SANDY CITY COMMUNITY DEVELOPMENT

MEMORANDUM

To: Planning Commission
From: Community Development Department
Subject: Bout Time Pub and Grub- Preliminary Site Plan Review SPR-06162021-6077
31 W. 10600 S. 4.35 Acres
[Community #9 – South Towne] AM Zone

Exhibit 1- Site Plan

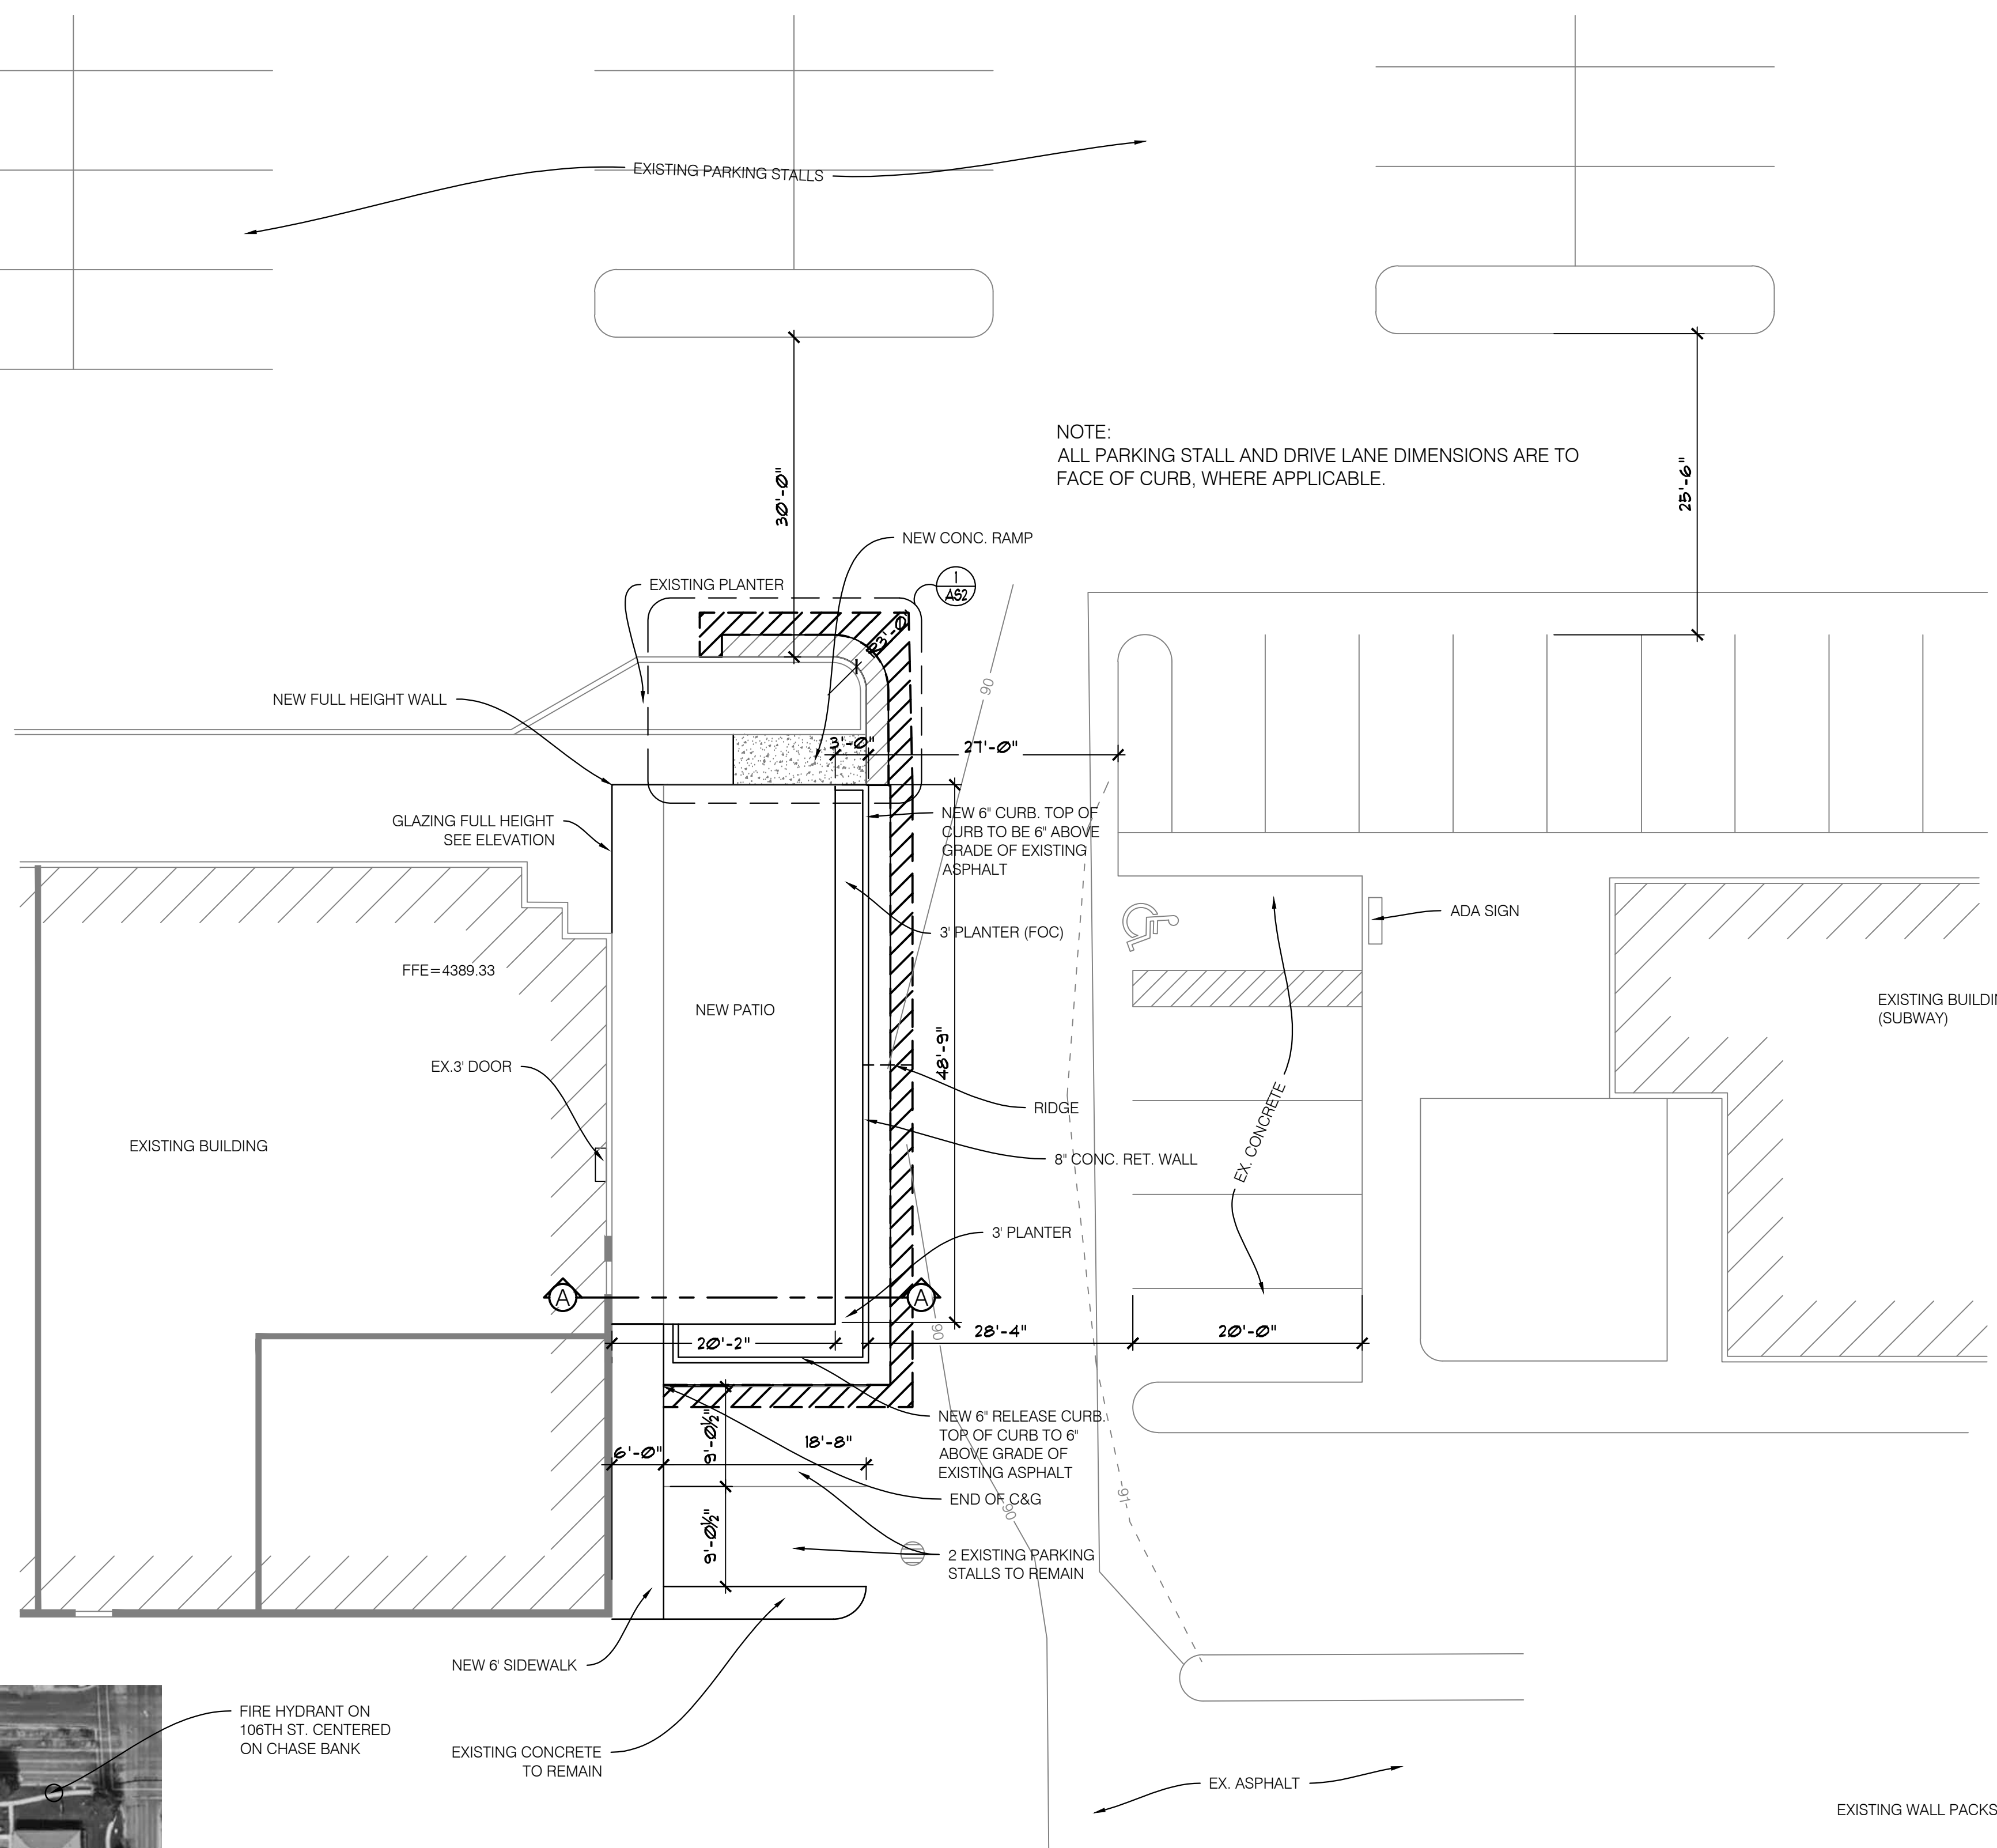
Zoning Review and Parking Reduction. The proposed project meets all of the requirements of the AM zoning district and the Sandy City Land Development Code, with the exception of meeting the zoning required number of on-site vehicle parking stalls, based on 5 stalls per 1,000 square feet of gross space. The applicant is proposing to eliminate six parking spaces in order to create the proposed patio addition. Section 21-24-3(c) of the Sandy City Land Development code states that the Community Development Director may grant reductions to parking stall requirements of up to 10 percent of the required amount, when the project meets one of five stated criteria in the section.

This project qualifies for up to a 10 percent or 19 parking stalls reduction, due to meeting one of the criteria namely subsection (1,a) Parking Demand Analysis. (Exhibit #2 – Parking Demand Analysis). The Parking Demand Analysis is a study provided by a licensed transportation engineer that demonstrates projected usage of residents, employees, and customers of the proposed land uses or similarly situated land uses in other locations. The study in question concluded that peak demand of the shopping center was approximately 131 parking spaces when all spaces within the shopping center are in use. The shopping center currently contains 186 parking stalls and the elimination would take that down to 180 which according to the study provided by Hales Engineering is ample parking to meet demand.

The Eat-A-Burger (Jamba Juice current location) was the last approved modification to the site plan in 1985. Staff has verified that this site is in compliance with the parking standards based on the amount of existing square footage and uses. This proposed addition would result in the loss of six existing stalls. The proposed addition would require five additional parking stalls. However, the Community Development Director can approve up to a 19 stall reduction (10% reduction from 186 stalls). The Community Development Director is comfortable with the proposed request and reduction in parking based on the aforementioned criteria being met. The history of this commercial center has not presented any parking problems.

1. That the developer proceed through the final site plan review process with staff prior to the start of any construction. The Final Site Plan shall be in compliance with all Development Code requirements and those modifications required by the Planning Commission.
2. That the development **comply with all Building & Safety, Fire and Life Safety Codes** applicable to this type of use.

Exhibit #4- Landscape Plan

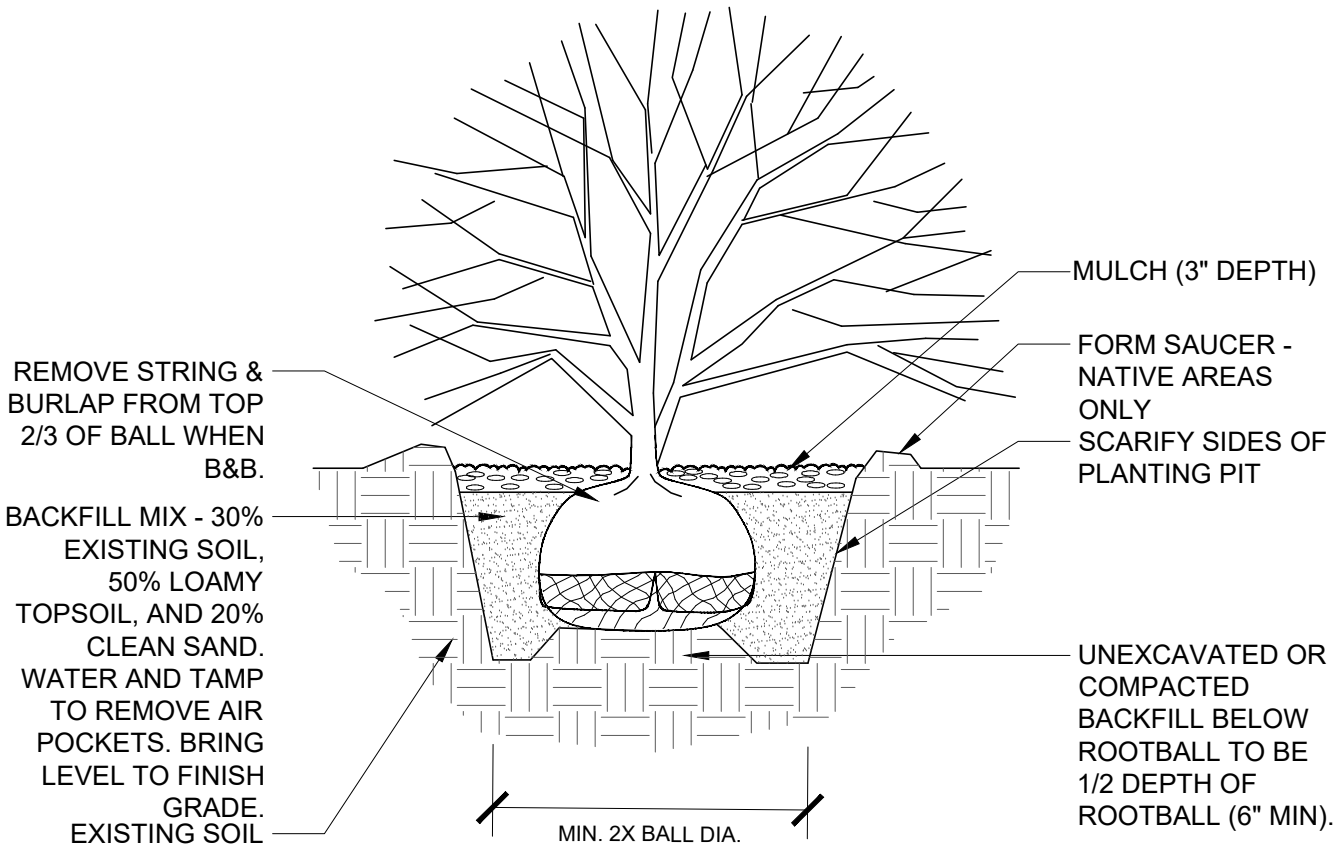
Landscaping and Erosion Control Measures. No changes to the site are proposed that would require erosion control measures. For landscaping the applicant is proposing a three-foot

planter box on the east and south sides of the addition as well as replacing the landscaping within an existing landscape planter on the north side of the building. (See Exhibit #4 – Landscape Plan)
